Subject: Duke Energy Corporation  
Oconee Nuclear Station - Units 1, 2, and 3  
Docket Nos. 50-269, 50-270, and 50-287

Revisions to Topical Report DPC-NE-3003 In Support of  
Steam Generator Replacement  
Response to NRC Staff Request for Additional  
Information

Enclosed herein, please find the Duke Energy Corporation (Duke) response to the May 12, 2003 NRC staff's request for additional information concerning topical report DPC-NE-3003, Revision 1, "Mass and Energy Release and Containment Response Methodology."

### **Duke Power Response To Request For Additional Information**

(14.1 ft<sup>2</sup> Break - RV Outlet - High Initial RCS Flow w/ M1 Pump Degradation Model)

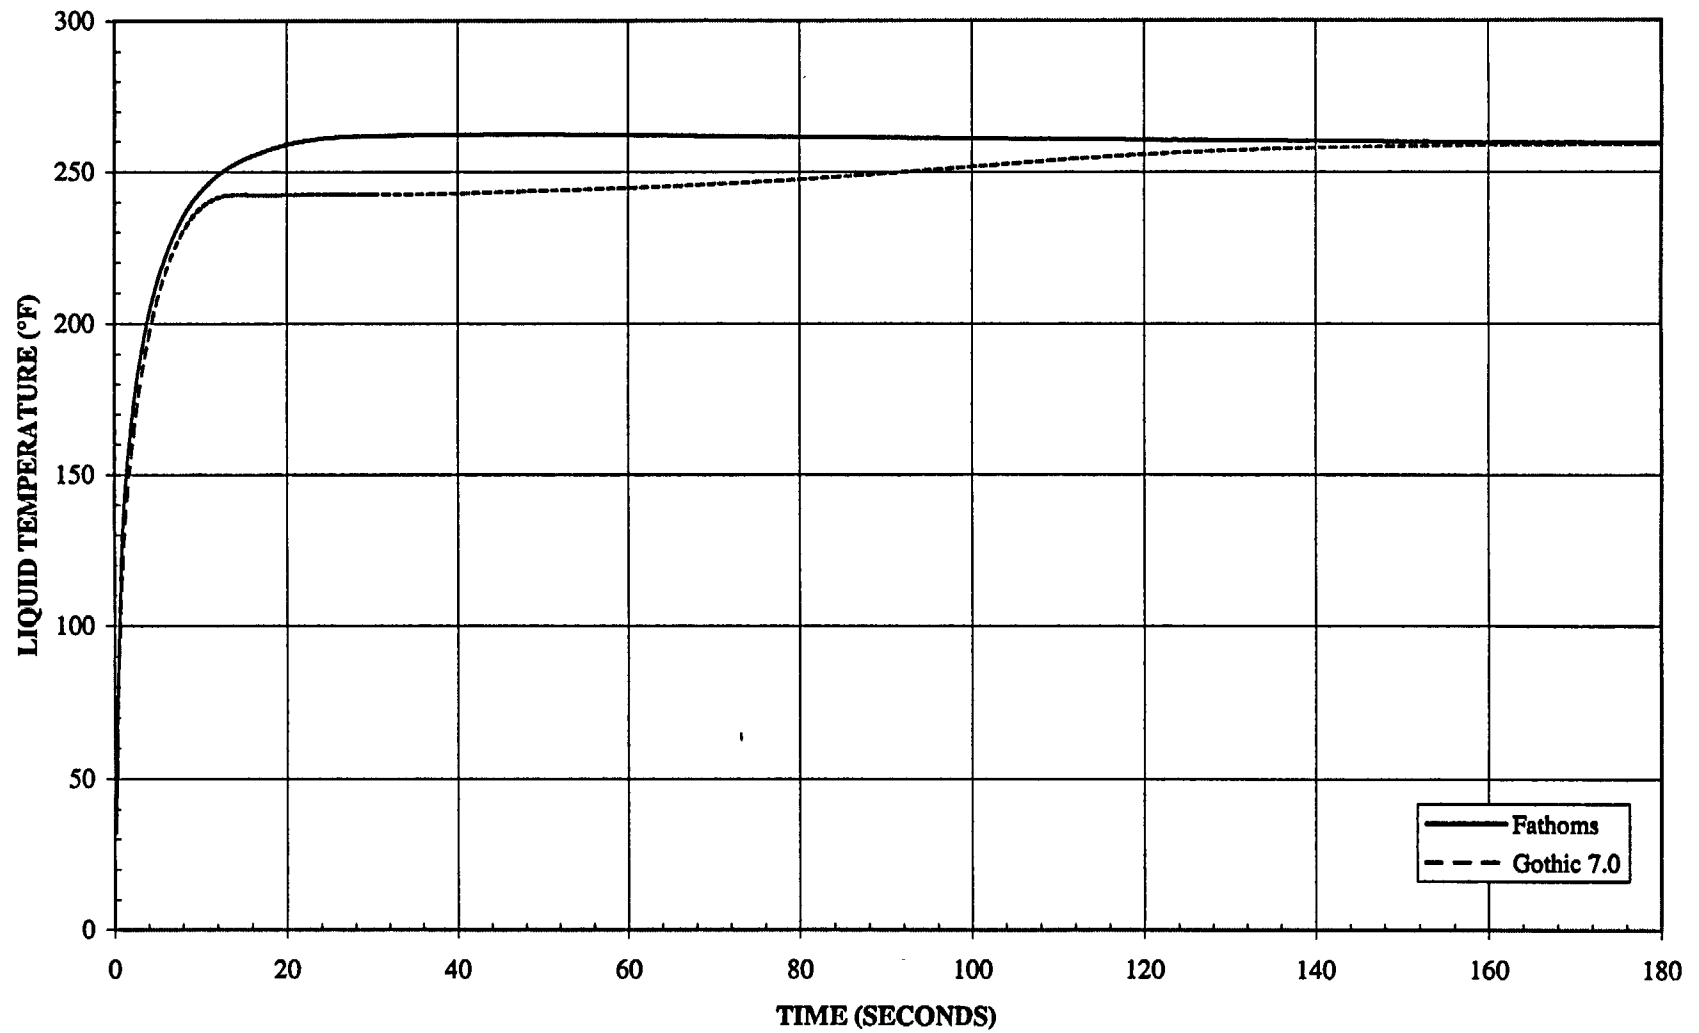
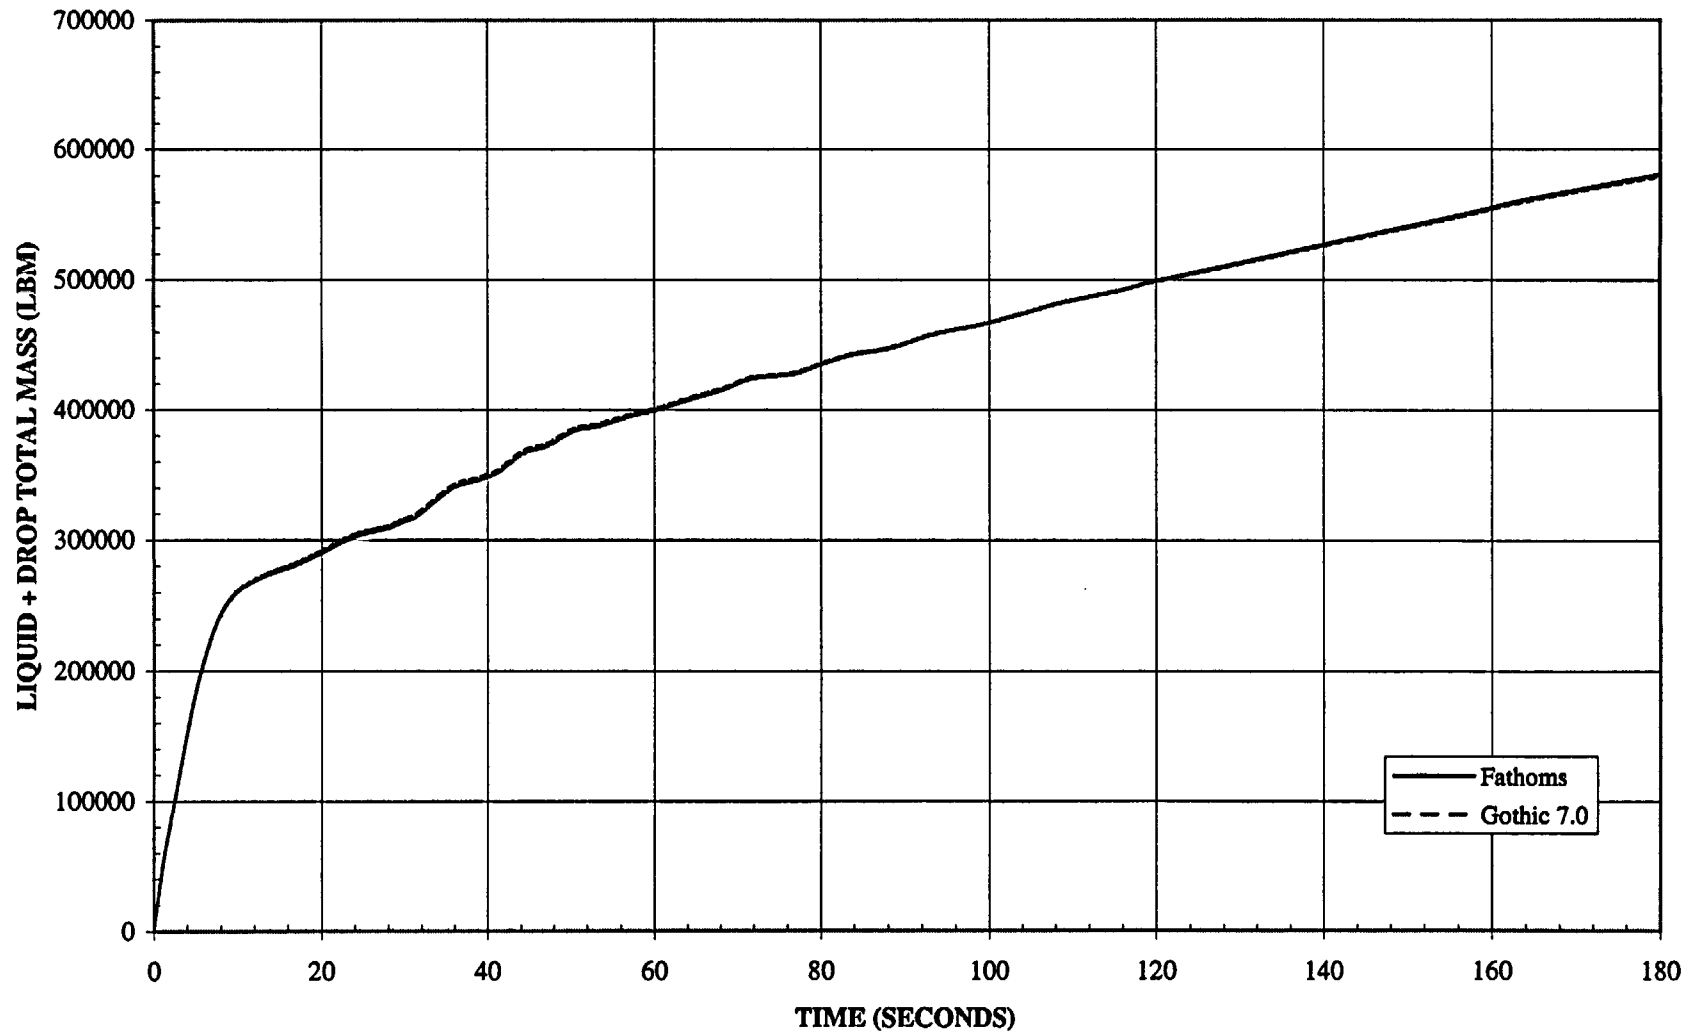
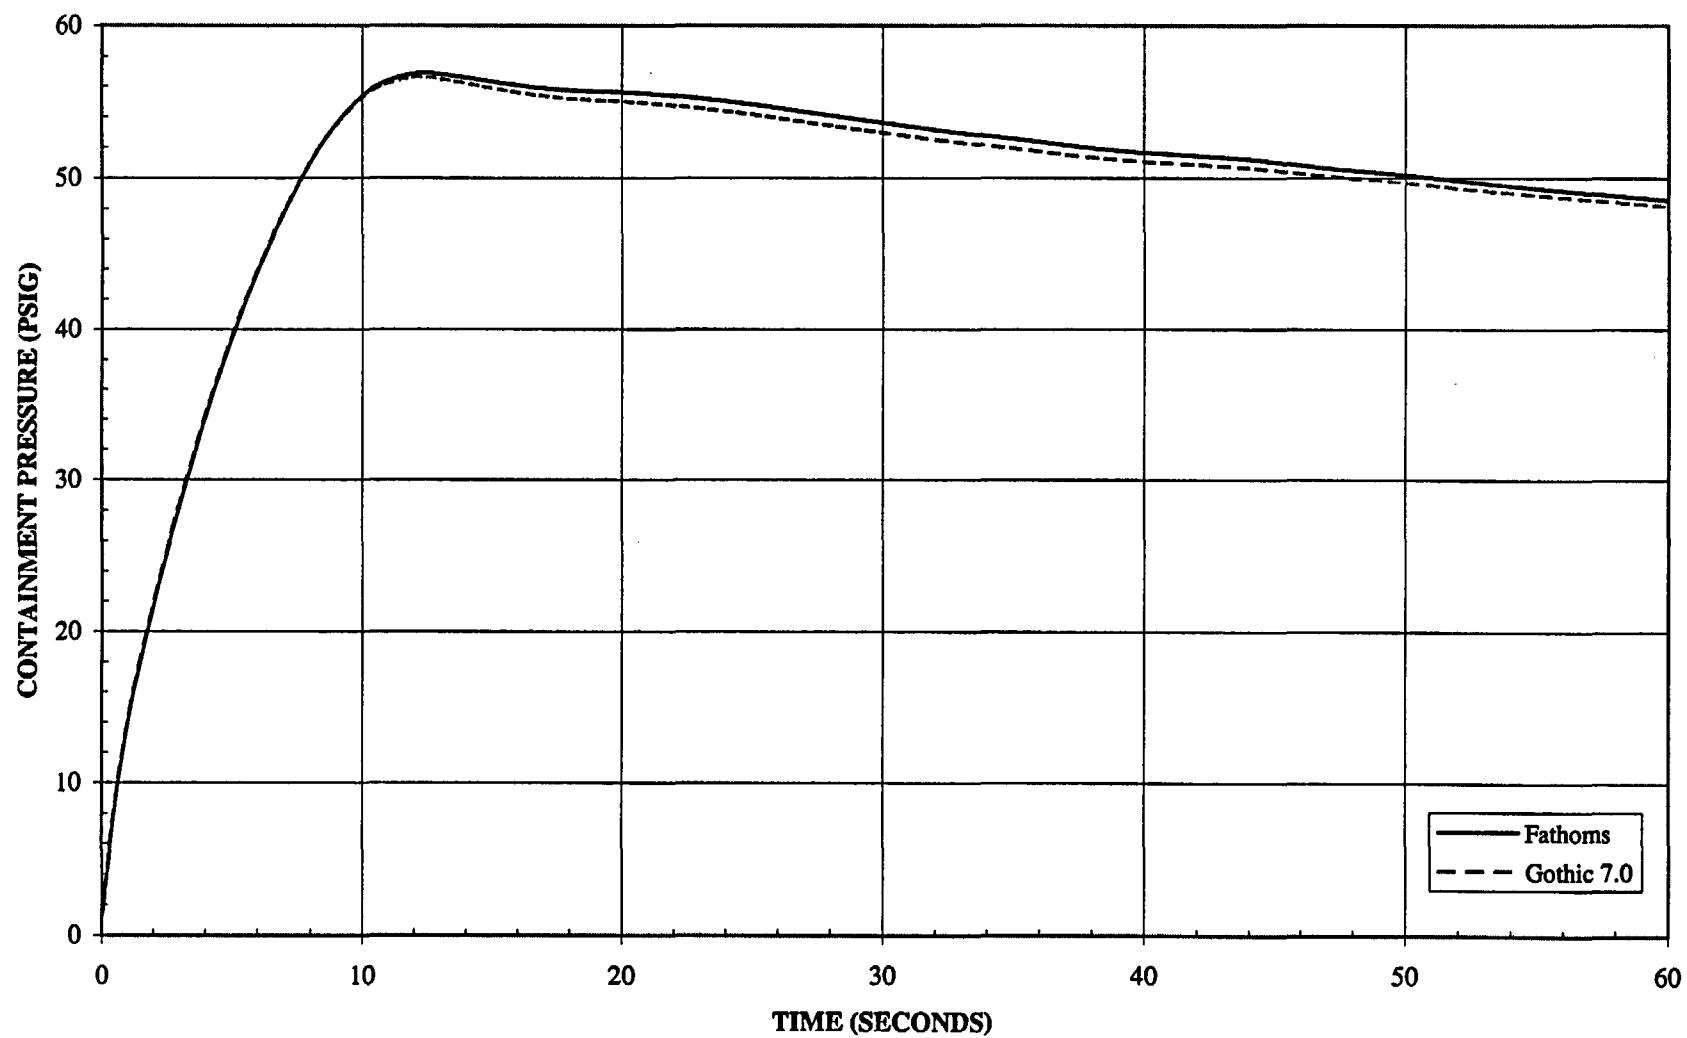
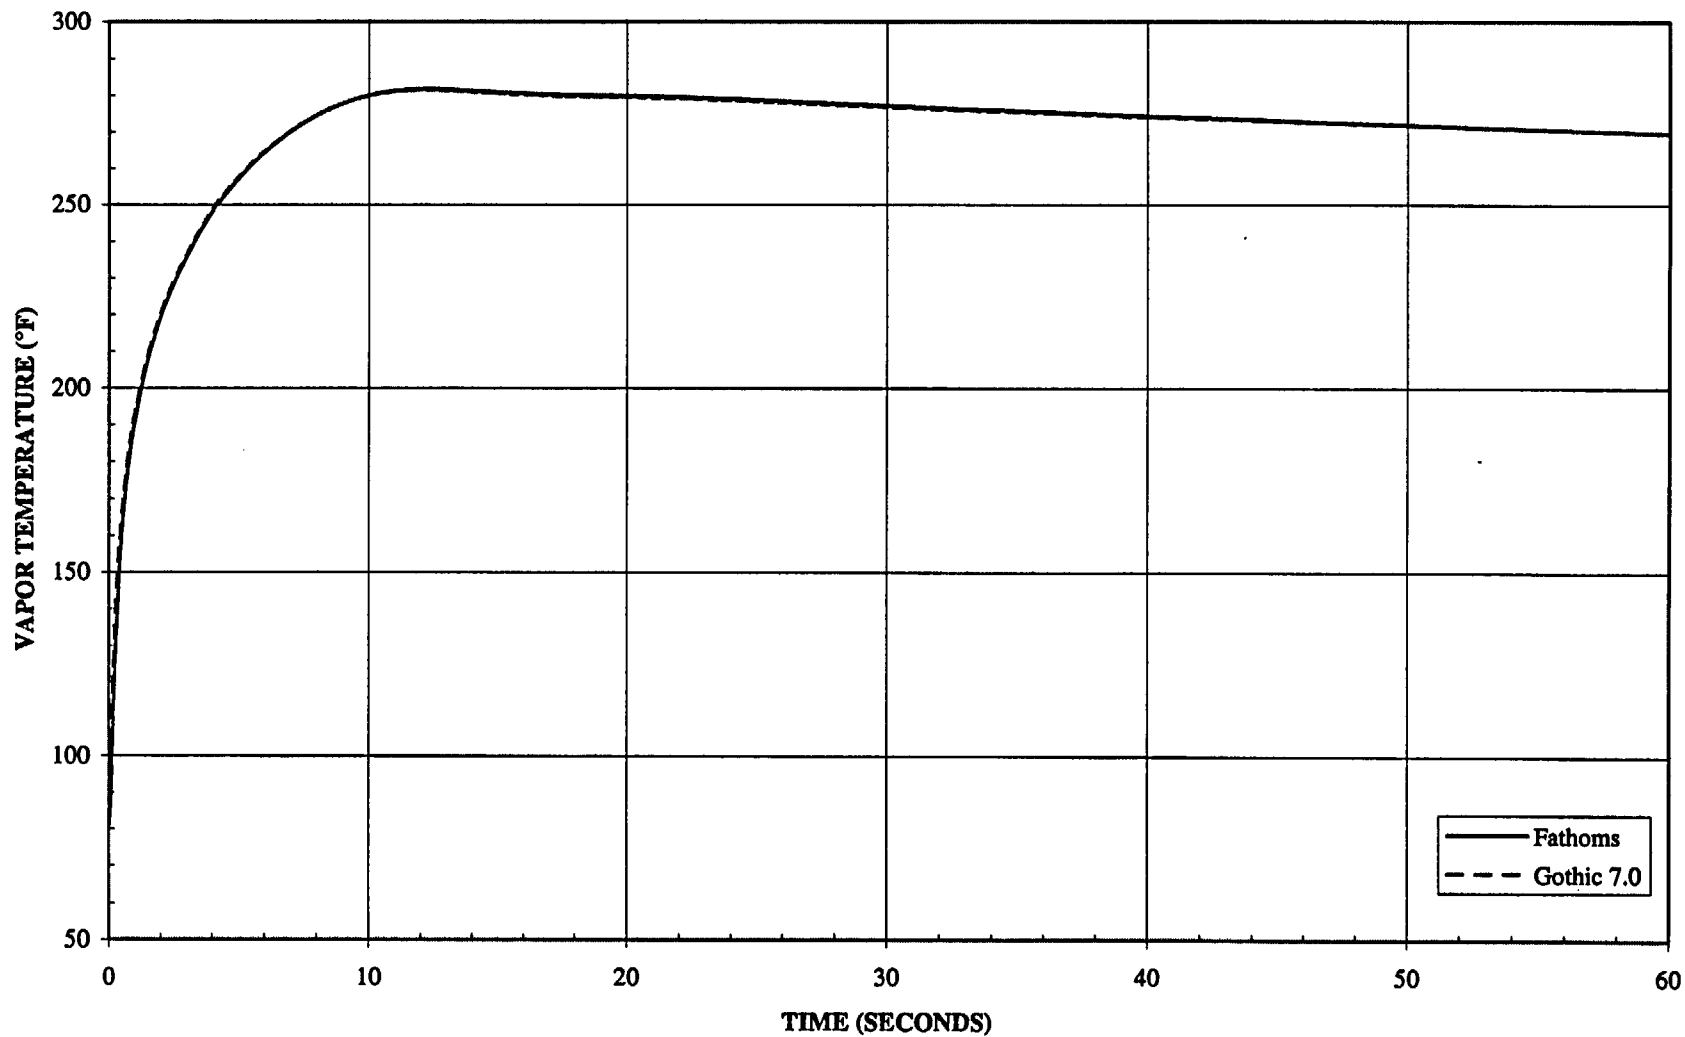
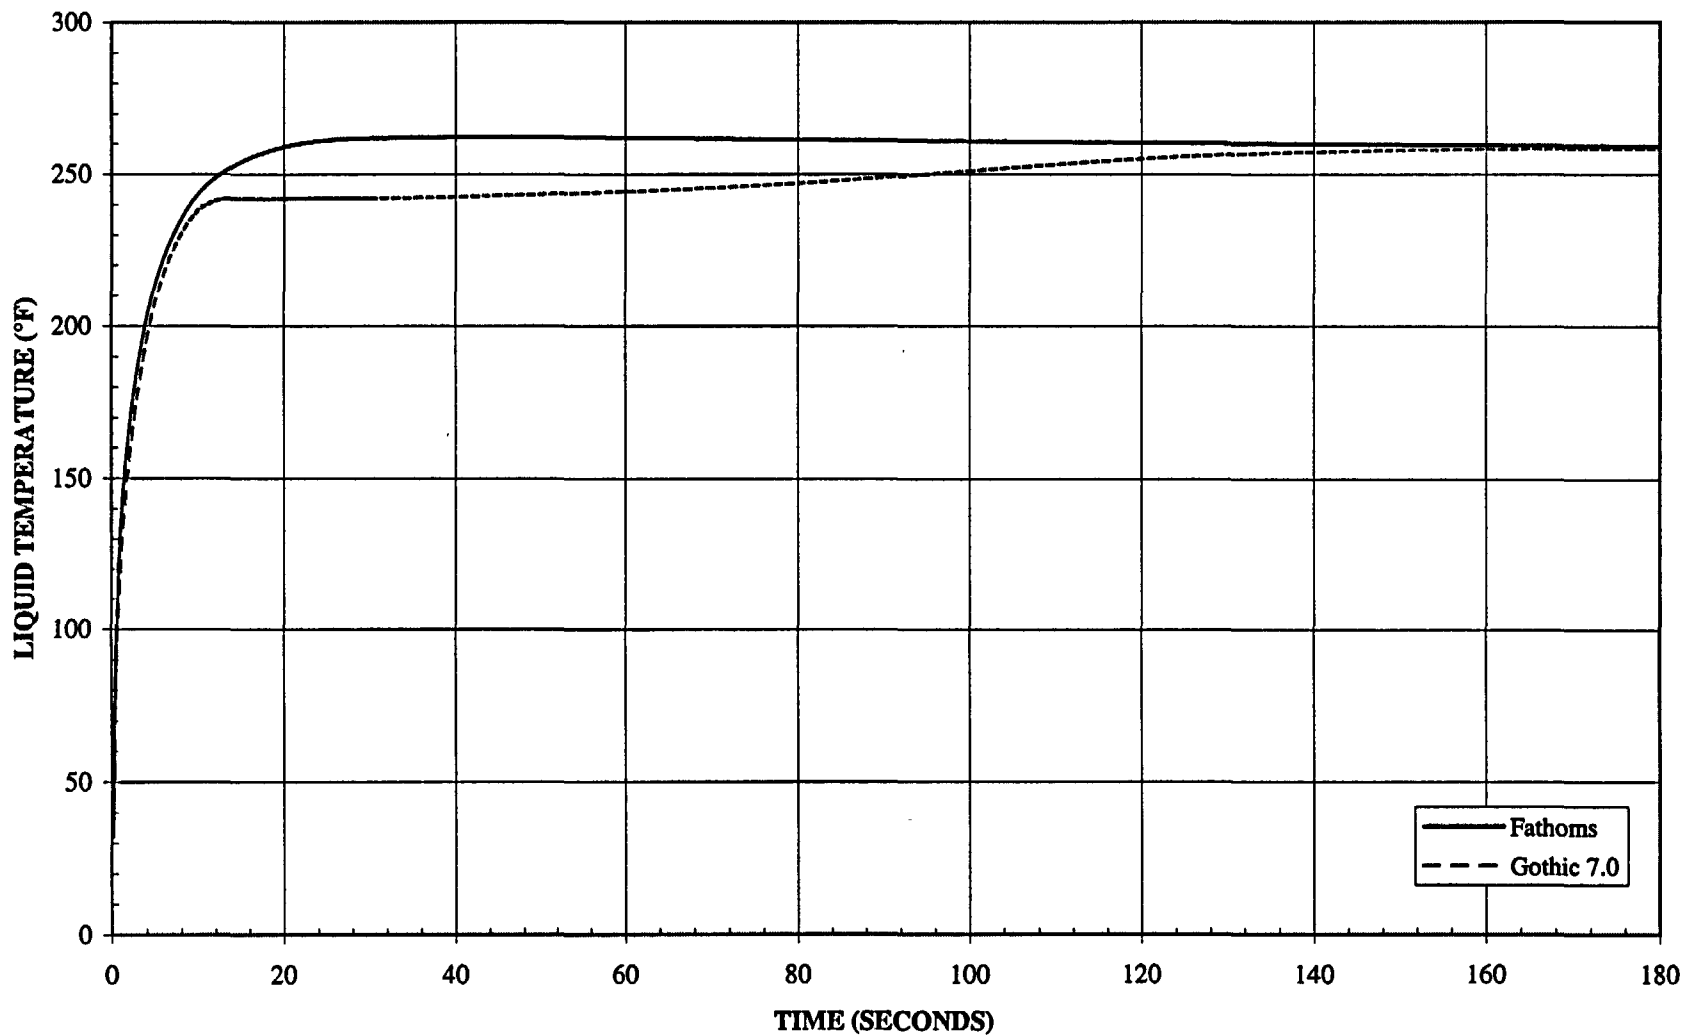
3. Please provide the results using the GOTHIC 7.0 code of peak pressure and temperature calculations for the sensitivity cases listed in Table 3.1-1 of DPC-NE-3003 in tabular and graphical form. If the results or conclusions are significantly different from those presented in DPC-NE-3003P, explain the difference.

Response: Table 3.1-1 of DPC-NE-3003 describes a spectrum of LOCA peak pressure cases including a range of break locations and sensitivity analyses for several important modeling assumptions. The staff's request is understood to focus on the difference in the predicted results from the FATHOMS and GOTHIC 7.0 code versions. Rather than show the comparison for the cases in Table 3.1-1, a different set of cases has been selected which is more focused on the current knowledge of the key sensitivity parameters. Also, the results presented are for the ROTSGs, which is the subject of Revision 1 to the topical report.

The results of the 14 code comparison analyses are shown in Table 3-1 below and in the figures that follow. In general, the pressure and vapor temperature response predictions were very similar in both magnitude and trend. GOTHIC 7.0 predictions for peak pressures and vapor temperature were slightly lower (~0.5 psig and 0.5°F). These differences are consistent with the code model differences described in the response to Question #1. Both codes predict a saturated containment atmosphere due to the large amount of drops injected. The slightly lower pressure, vapor temperature, and liquid temperature from GOTHIC 7.0 may be attributed to additional drop hold up in the atmosphere. This effectively increases the heat capacity of the atmosphere and reduces the temperature rise for a given energy addition. A comparison of the total liquid and drop masses, and liquid temperatures, show the predictions of the two codes to be essentially the same. This is consistent with the changes in the drop deposition and entrainment models discussed in Question #1. These results show that the two code versions give essentially similar results for the same break location and initial and boundary conditions.
